11 March 2024

**Waitomokia RFI: Addendum Hydrogeological Technical Memo - 118 Montgomerie Road, Mangere, Auckland**

**(Our Reference: 18043.000.001\_09)**

Figure 2-2: Waitomokia & Otuaatua Revised Conceptual Model

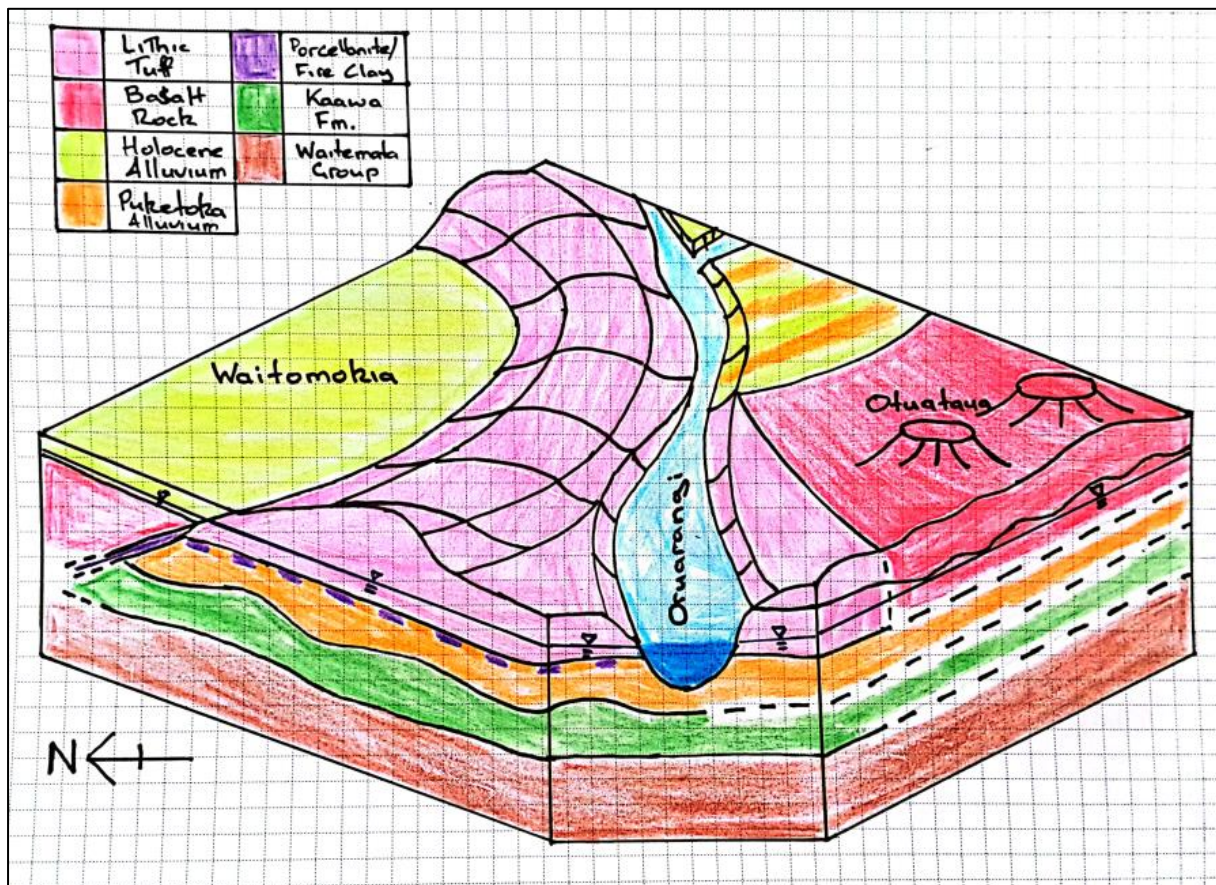
*Please provide further information on the hydrogeological links between the volcanic aquifer and underlying aquifers so these links can be adequately assessed in relation to the plan change proposal, particularly regarding groundwater flow and recharge, and potential adverse effects on the underlying aquifers should appropriate mitigation measures not be adopted by the plan change proposal to address such effects where required.*

With respect to potential linkages between the Waitomokia crater area and aquifer units below the Otuataua Volcanic Aquifer, we refer to the hydrostratigraphic conceptual model revisions presented in Section 2.

The site itself is underlain by the Otuataua Volcanic Aquifer, with the Mangere-Manurewa Kaawa Aquifer and Manukau North Waitemata Aquifers located at depth below. While the presence of the stratigraphy itself is not disputed, the hydrostratigraphic nature of the materials and their ability to function as water bearing aquifers is considered relatively circumspect. Alteration from contact metamorphism is likely to have reduced the 'aquifer potential' directly adjacent to the Waitomokia volcanic vent.

Notwithstanding the above, the presence of the lower permeability Puketoka Formation strata between the shallow volcanic aquifer and the deeper sedimentary aquifers (Kaawa & Waitemata) is considered to preclude recharge to the deeper aquifers from surface infiltration within the Waitomokia crater.

As indicated in the updated conceptual model, the intervening Puketoka Formation strata are connected to the coastal constant head boundary at Oruarangi Creek. As such, ENGEO considers that any reduction in recharge to the Waitomokia portion of the Otuataua Volcanic Aquifer is unlikely to impact the quantum or quality of groundwater availability in either the Mangere-Manurewa Kaawa or Manukau North Waitemata Aquifers as the head pressure in the deeper aquifers is largely controlled by coastal heads so far as influences from within the Waitomokia area are concerned.

Figure 7-1: Auckland Council Database Search – All WAT/LUC & Historic Consents

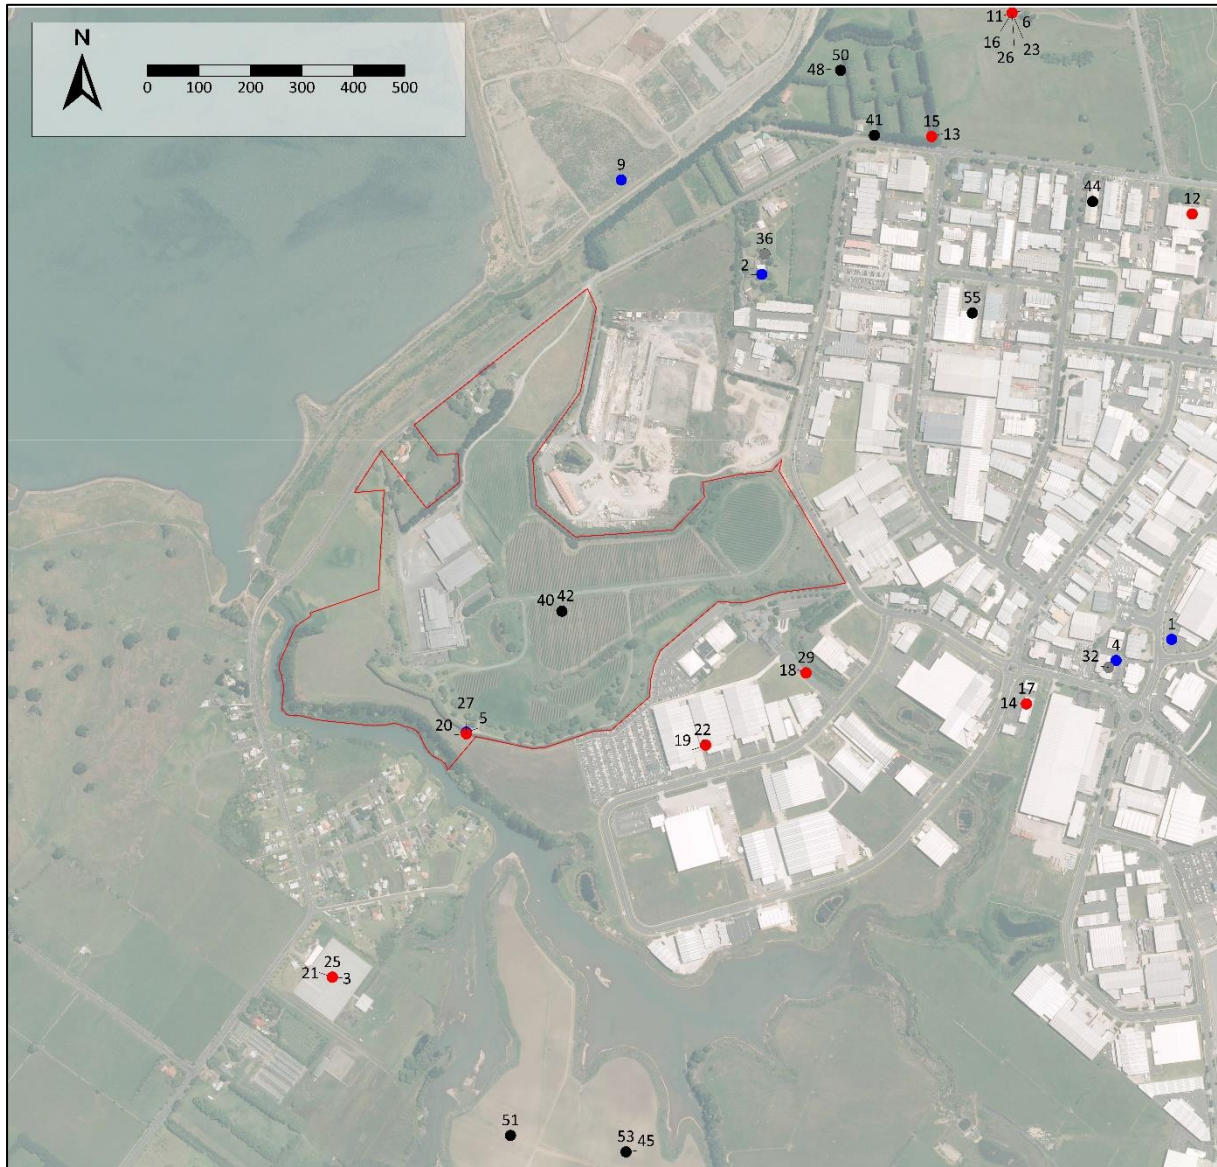
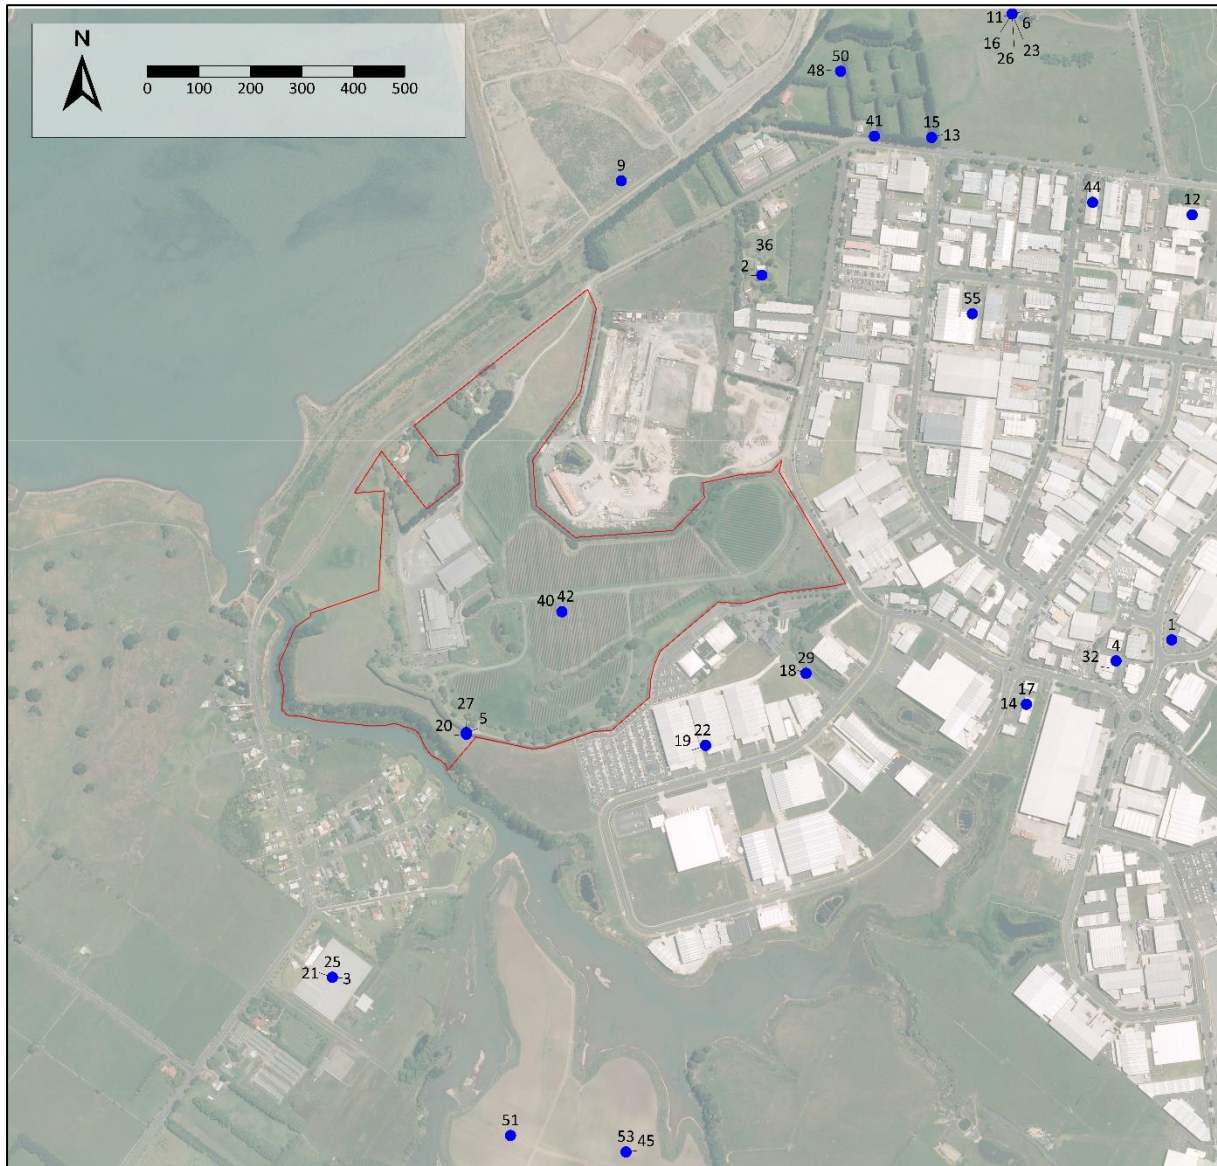
*Please provide further information on existing and future groundwater use, including any known or anticipated future taking of water from aquifers within the plan change precinct by associated users, area these links can be adequately assessed in relation to the plan change proposal, particularly regarding groundwater flow and recharge, and any effects the plan change may have on existing and future groundwater use within the proposed precinct.*

With reference to the summary of existing groundwater users in the local area (Section 3) we note the following:

- No existing groundwater-supply user has been identified that abstracts from the Waitomokia portion of the Otuataua Volcanic Aquifer.
- No existing Permitted Activity bore, either recent or historical, has been identified within appreciable distance of the site that might represent potential for a Permitted Activity Groundwater abstraction.

Figure 7-3: Extended Groundwater Monitoring

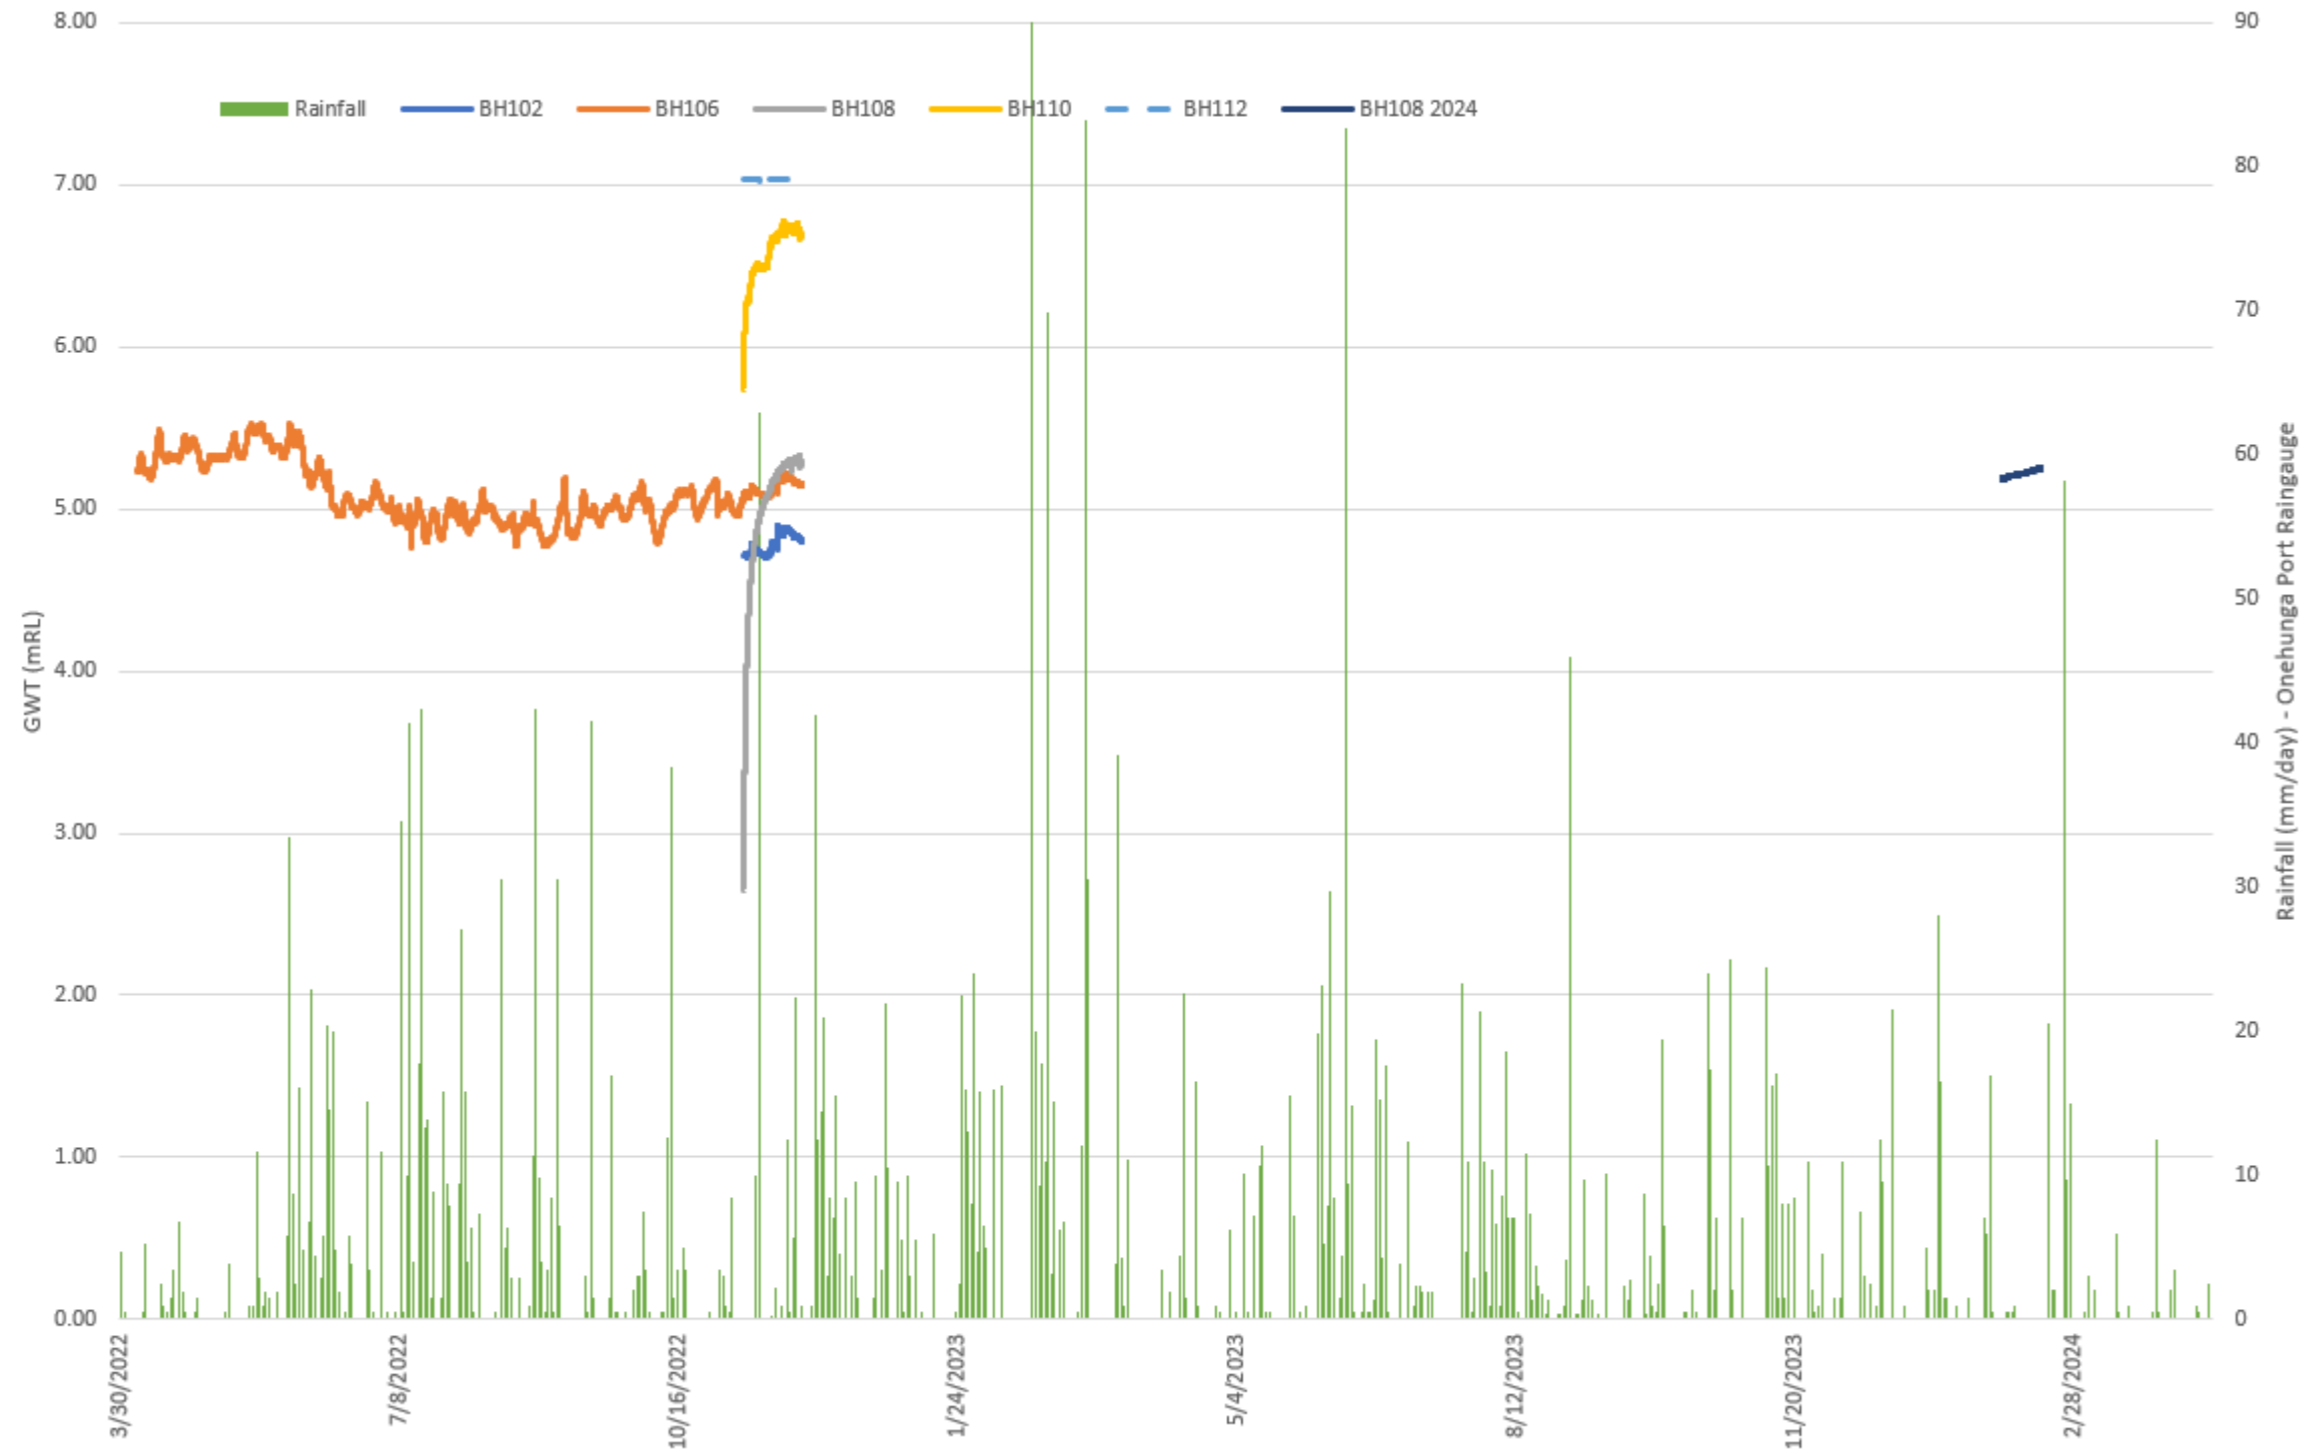
*Please provide an updated hydrogeological assessment which provides sufficient monitoring data over the longest period of time possible in Summer and Winter to adequately assess groundwater sources and levels inside the plan change precinct area, including the underlying Puketoka Formation, noting this will require the installation of additional groundwater monitoring boreholes, both across the area and into the Puketoka Formation.*

Please refer to Section 4 and Attachment 3. Updated groundwater monitoring plots for the site indicates no more than approximately 0.7 m of seasonal fluctuation in groundwater levels within the Otuataua Volcanic Aquifer (BH108).

As such, ENGEO considers that the extent of groundwater monitoring undertaken to date sufficiently characterises the ranges of anticipated levels within the Otuataua Volcanic Aquifer at the Waitomokia crater area.
